NOTICE OF DENIAL

RE: Application Number 22-8057; 691 W. Canfield; West Canfield Historic District

CERTIFICATE OF APPROPRIATENESS

691 W Canfield SCOPE OF WORK

IV. & V.
EAST SIDE

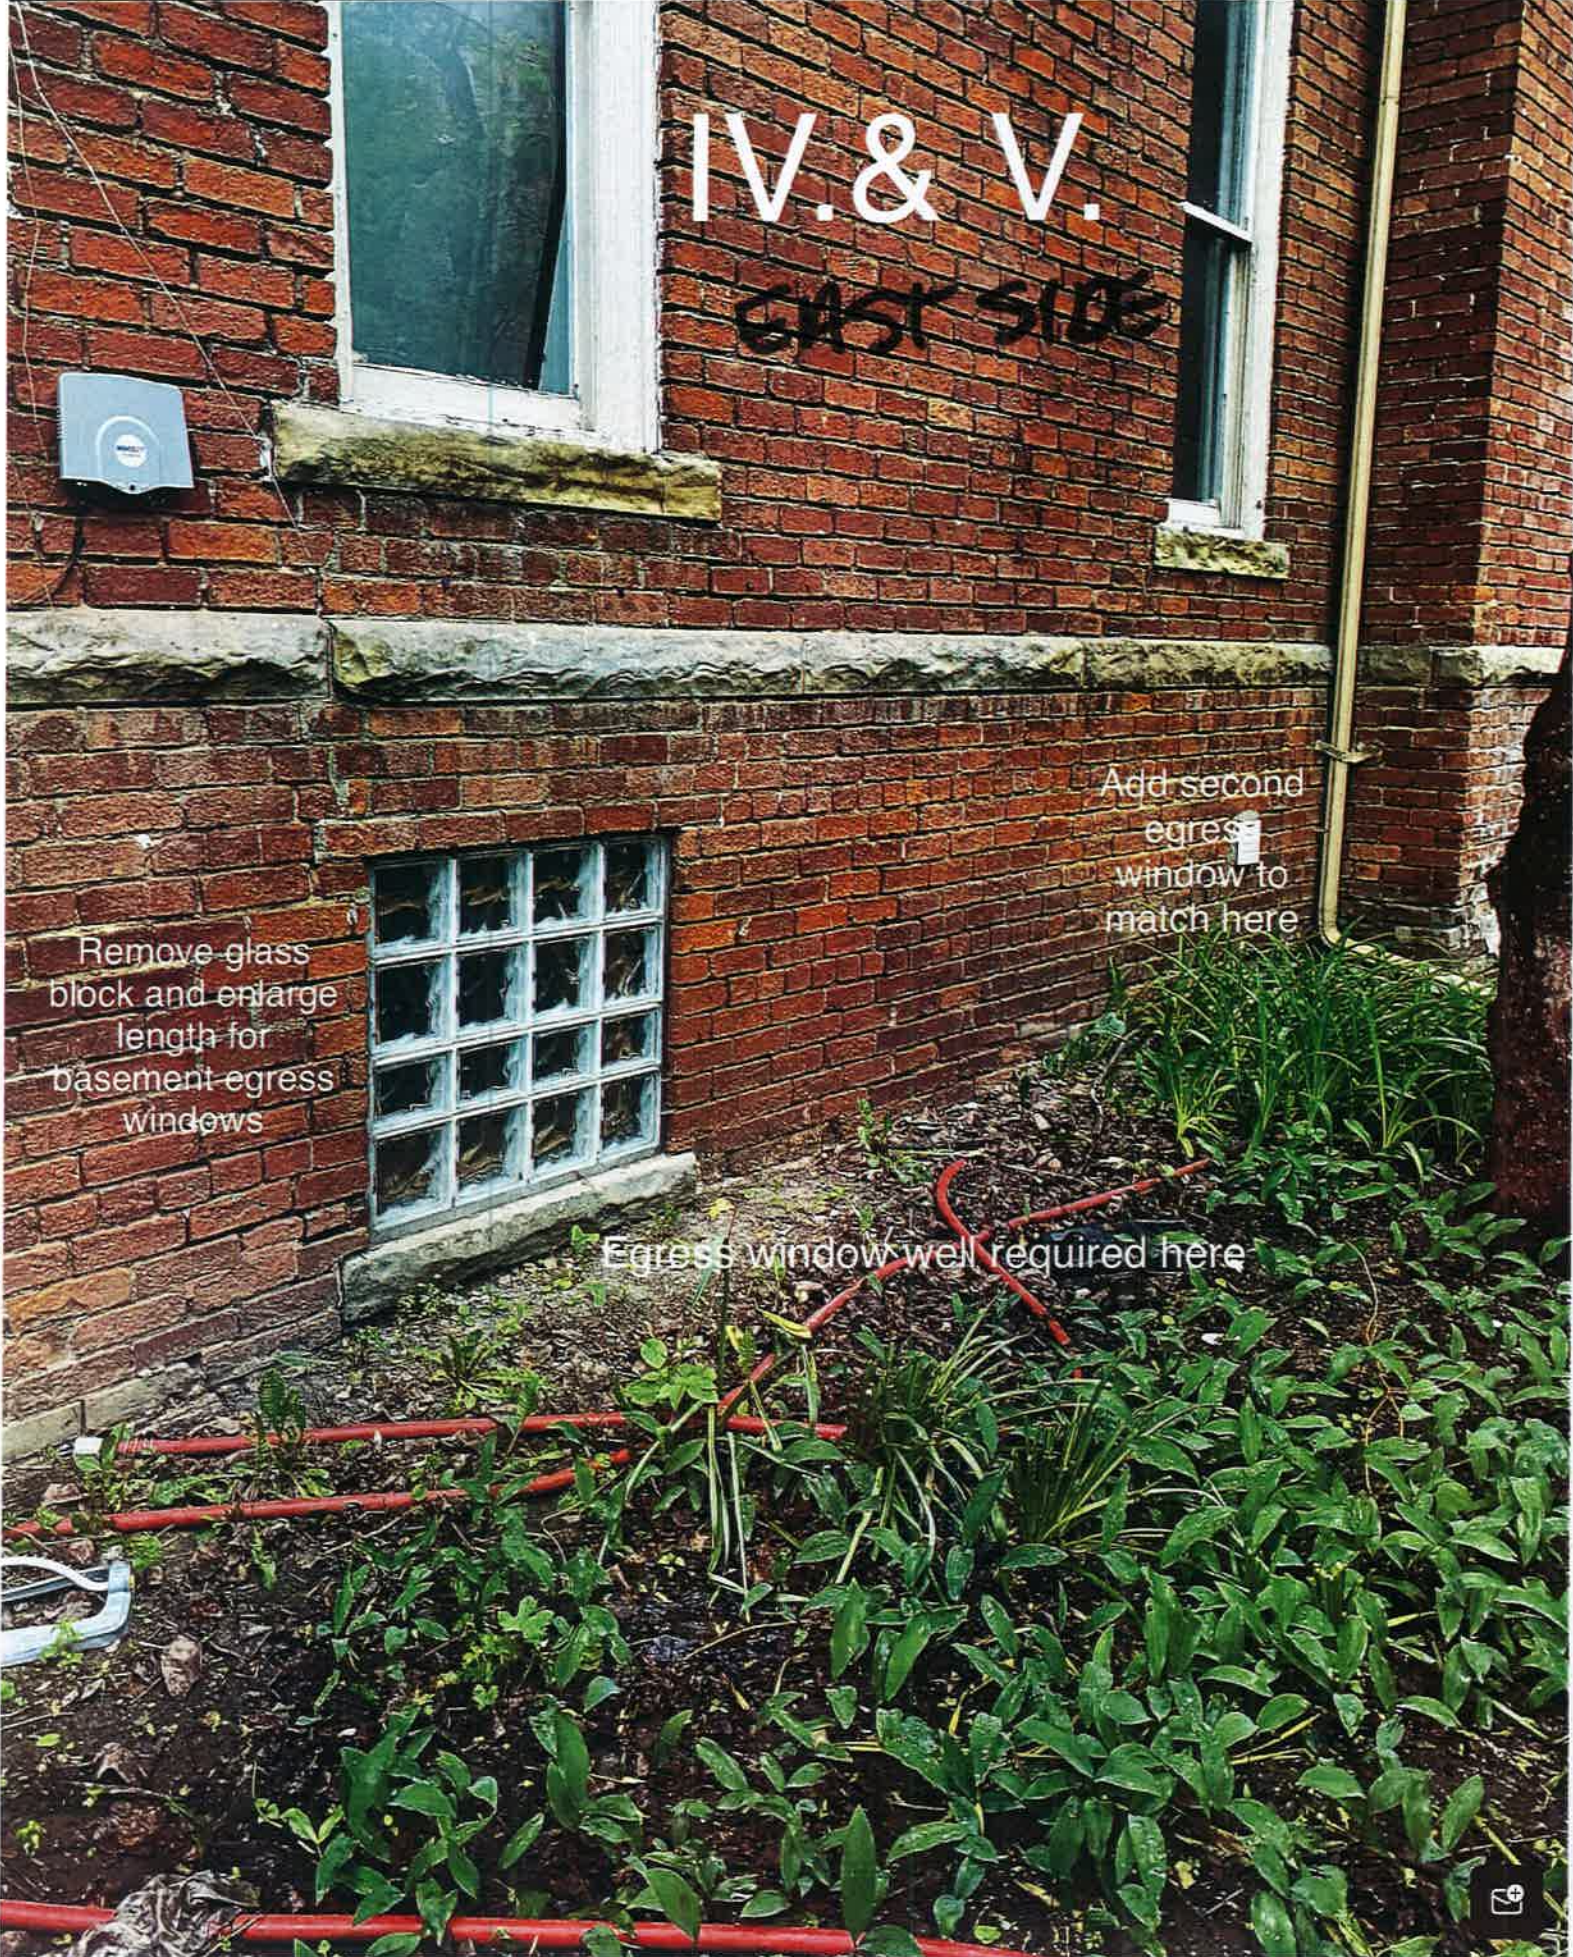
Remove glass
block and enlarge
length for
basement egress
windows

Add second
egress
window to
match here

Egress window well required here
